STATE OF UTAH  
NATURAL RESOURCES  
Oil, Gas & Mining

RE: Extension of January 1, 1985 Deadline for Sampling Area C,  
Hiawatha Complex, ACT/007/011, #3 and #7, Carbon County,  
Utah

RE: Response to Letter Received November 16, 1984 for Notice of Violation N84-4-8-8, #2 of 8, Hiawatha Complex, ACT/007/011, #3 and #7, Carbon County, Utah

RE: Review of U. S. Fuel Company's Abatement Plans for Notice of Violation N84-4-8-8, #6 of 8, Hiawatha Complex, ACT/007/011, #3 and #7, Carbon County, Utah

1. Diagram of segment of Middle Fork Haul Road in question taken from Exhibit VIII-2B to the Company's Interim Permit.
2. Violation No. 2 of 8 under NOV N84-4-8-8 received by the Company on May 15, 1984.

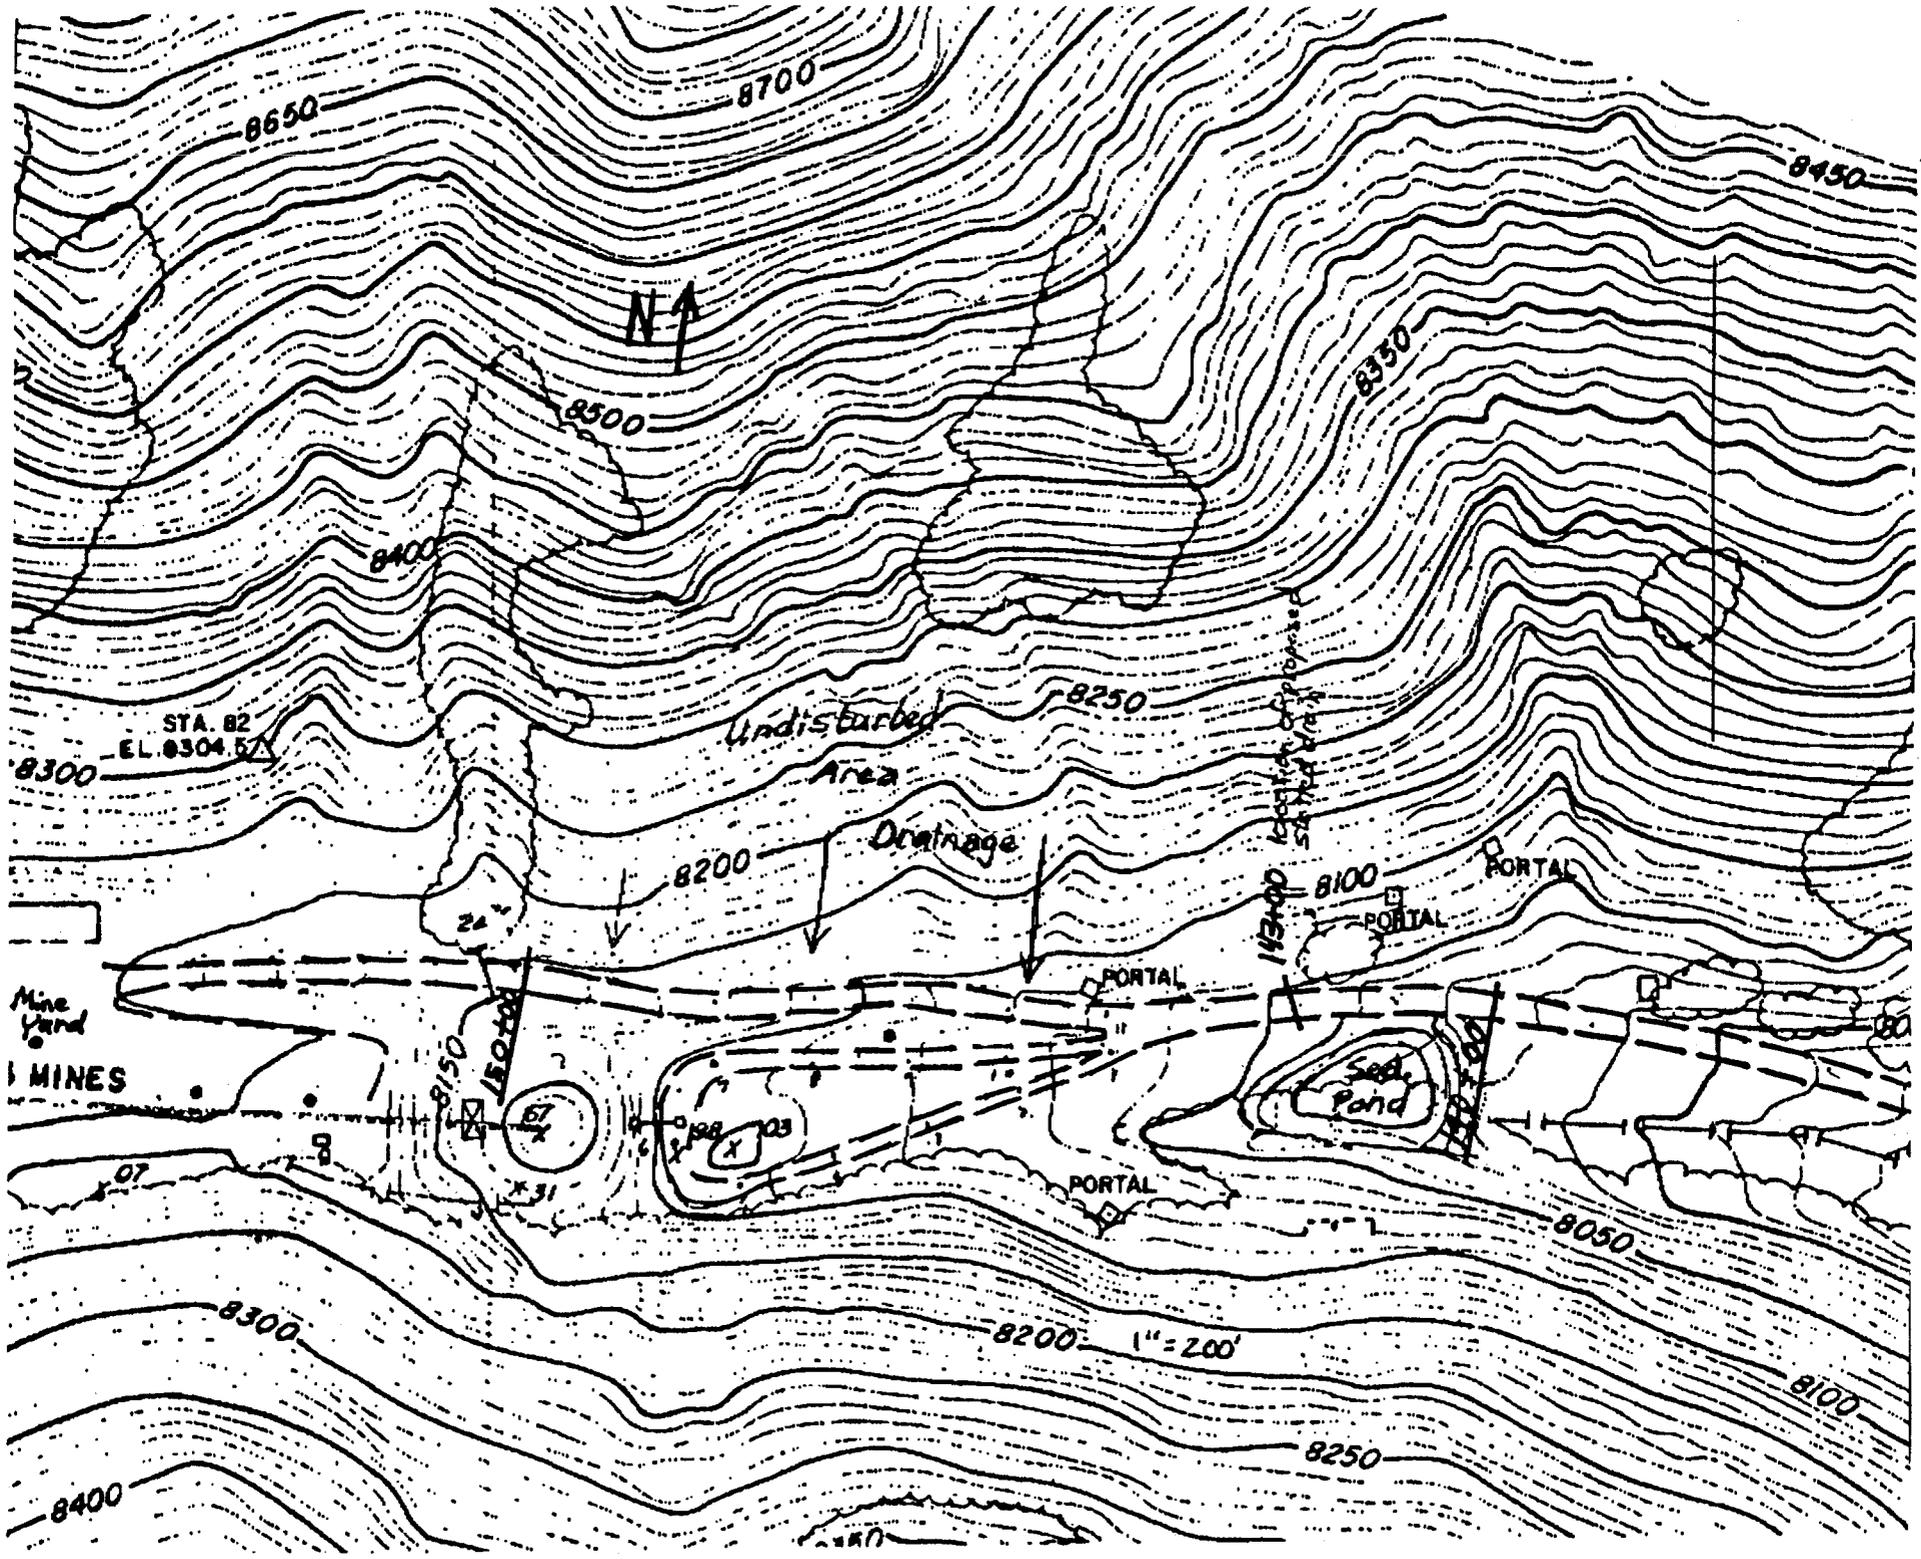
The area in question involves a paved segment of the Middle Fork Haul Road between stations 150+00 and 143+00, as depicted on the enclosed diagram. The area was the subject of Violation No. 2 of 8 under Notice of Violation N84-4-8-8 issued by Division Inspector David Lof. As indicated by the foregoing documents, the Company has consistently taken the position that the area was in compliance with the Division's regulations and the Company's Interim Permit and not in need of any further drainage controls.
